January 11, 2022
7:00 PM
Planning Board Agenda

Public hearing on applications for Subdivision Approval (lot merger) and Site Plan Approval, three-story mixed-use residential and commercial development, 364 Main Street, submitted by O'Donnell Construction Corp.

Re: 364 Main Street, Beacon, New York
Site Plan Application – Responses to Comments

Sheet 4 of 13 - Landscape and Lighting Plan

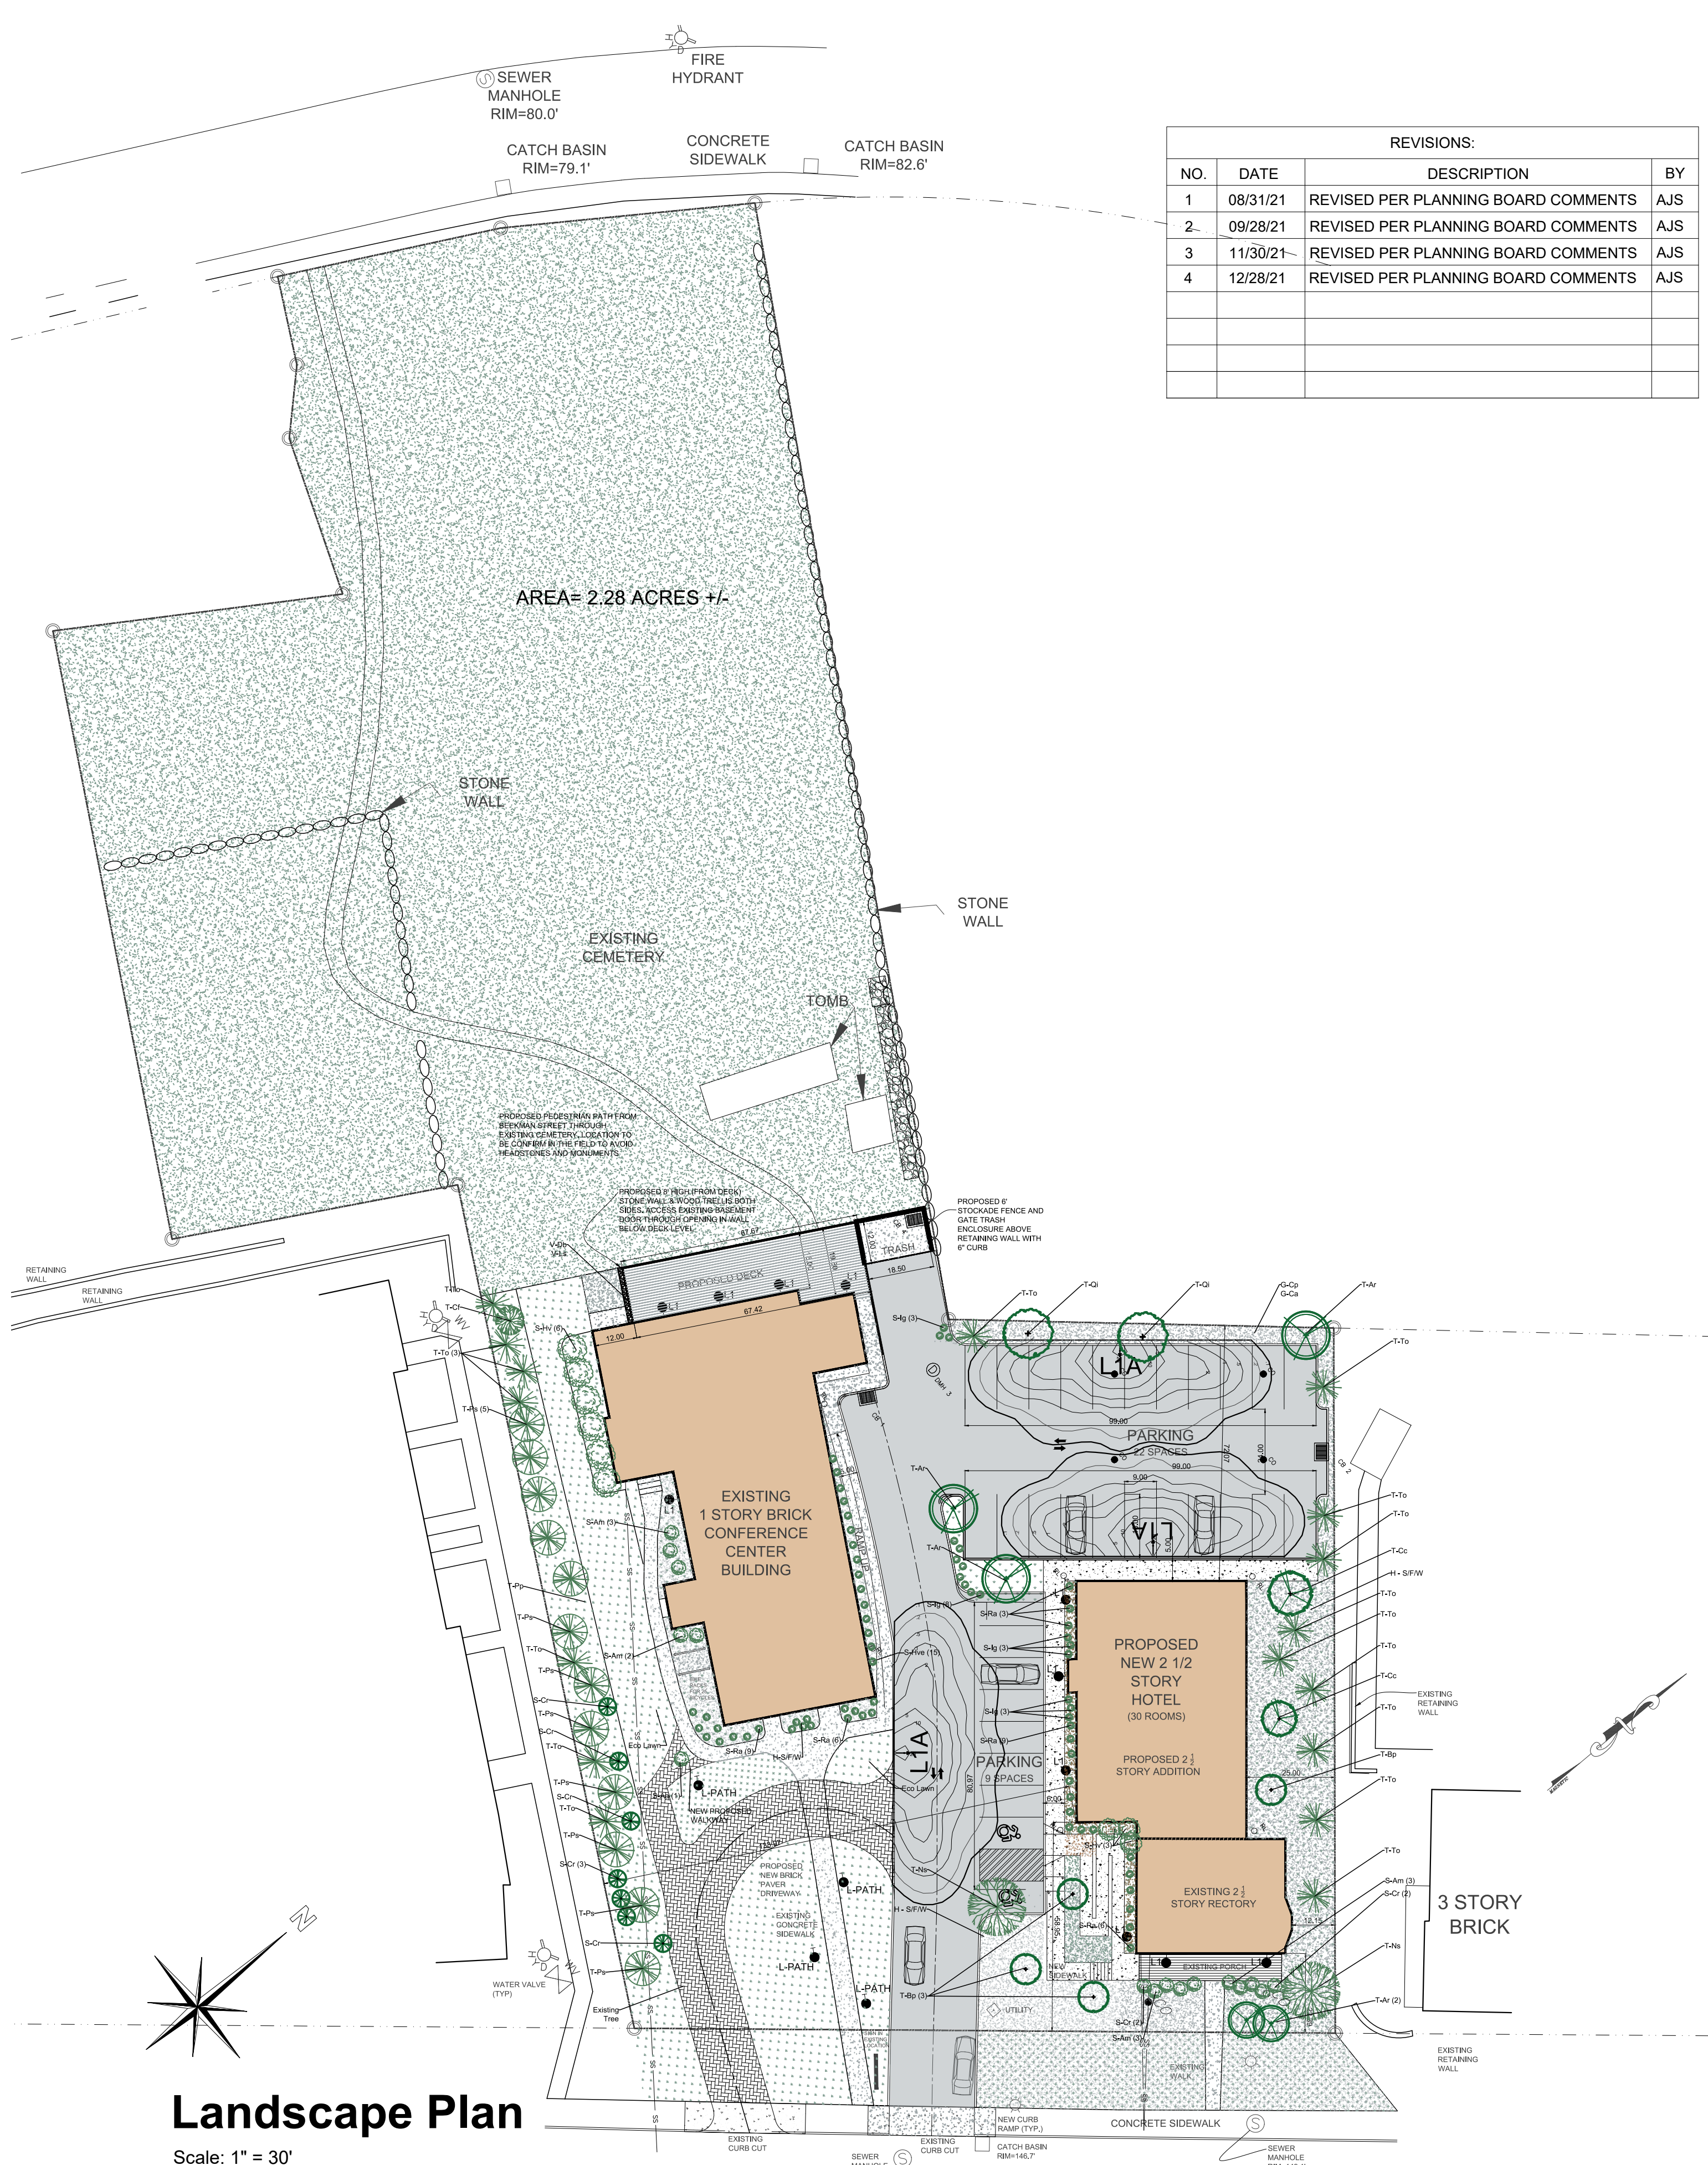
3. For Sheet 4:
- a. A very large Sycamore tree is located near the sidewalk on the southeast corner of the property. However, the proposed loop drive would now remove this beautiful tree, which is an essential part of the historic church landscape. This should be unacceptable.

- c. New light fixtures should not be attached to the front side of the church (the Sheet 4 lighting for the church does not match sheets 1 and 2). There are already historically compatible lights over the front two doors and any new attached lights toward the back should be consistent with them.

3. For Sheet 4
 - a The lighting specifications are shown on Sheet 4. No fixtures will be added to the church building.
 - b Canopy street trees and additional low landscaping have been added in front of the hotel.
 - c Additional plantings have been added to the rear parking lot to help screen views from the neighboring residences.
4. The hotel floor plans have been corrected to show 30 rooms instead of 31 rooms. Elevations have been added to the set.

Sheet 5 of 13 - Hotel Plans & Elevations

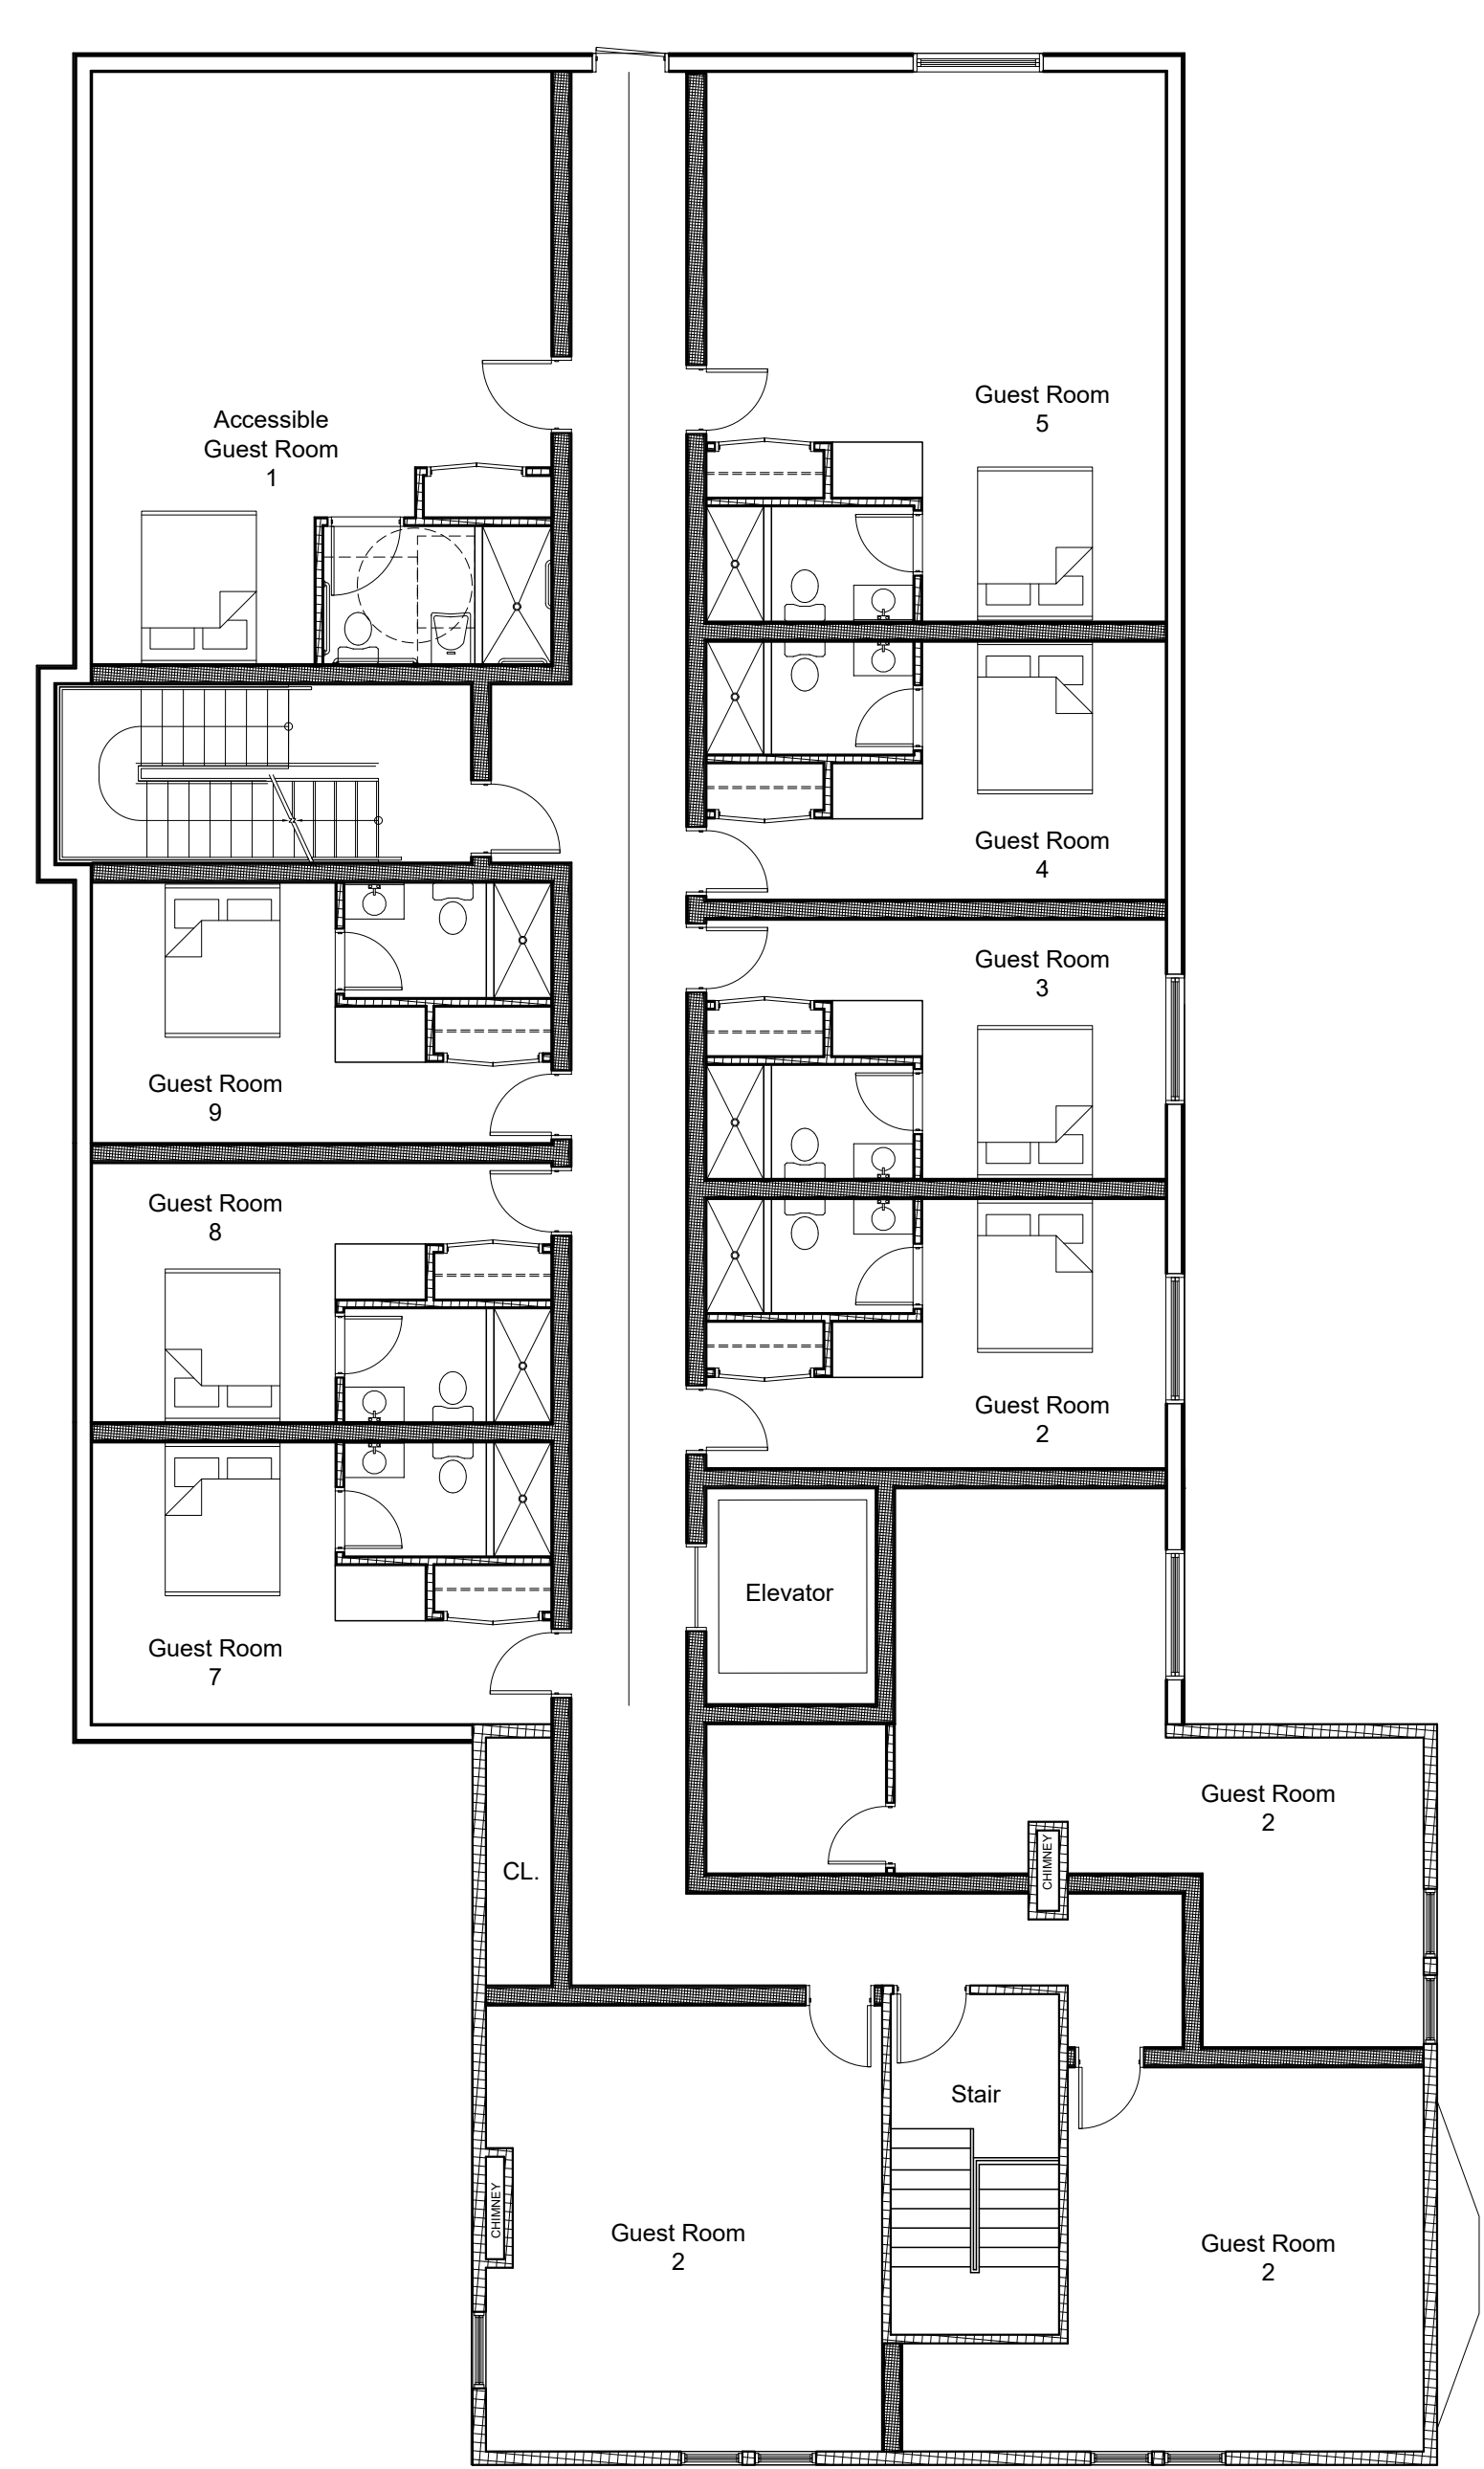
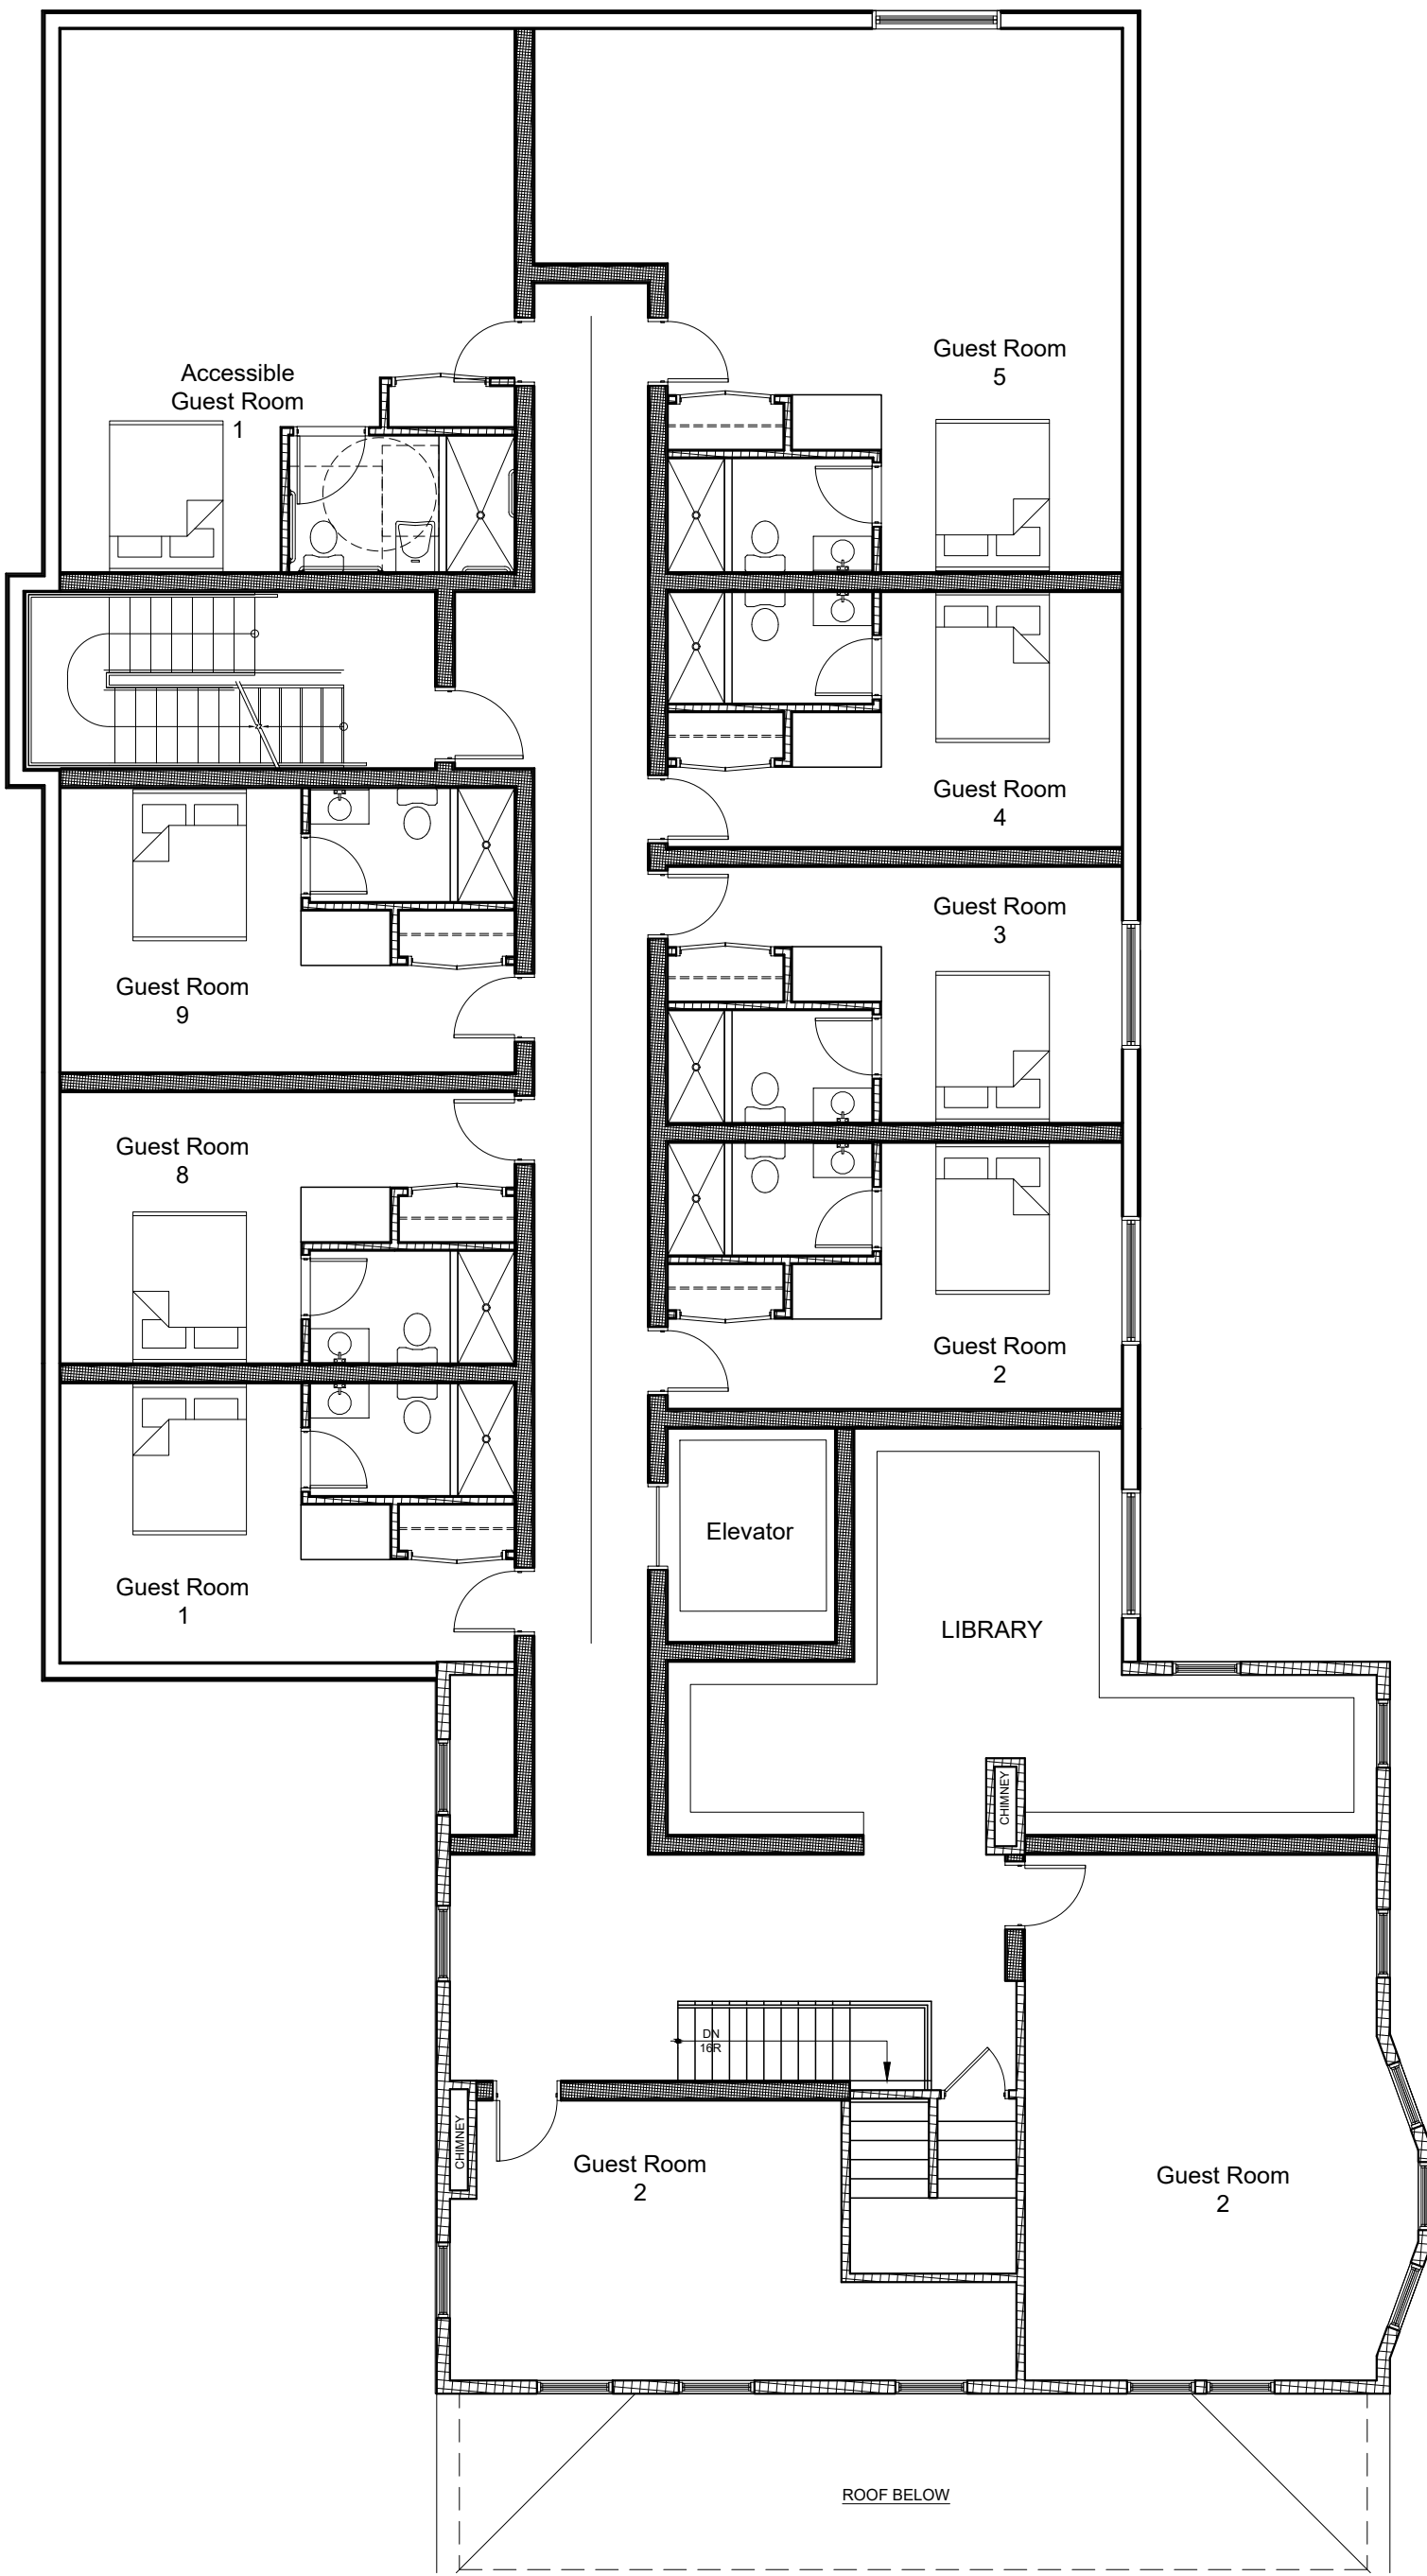
4. On the Sheet 5 Floor Plans, 31 guest rooms are still shown. The hotel elevations will need materials and colors identified.
5. All exterior construction must meet the standards in Chapter 134, Historic Preservation, and will require a Certificate of Appropriateness.
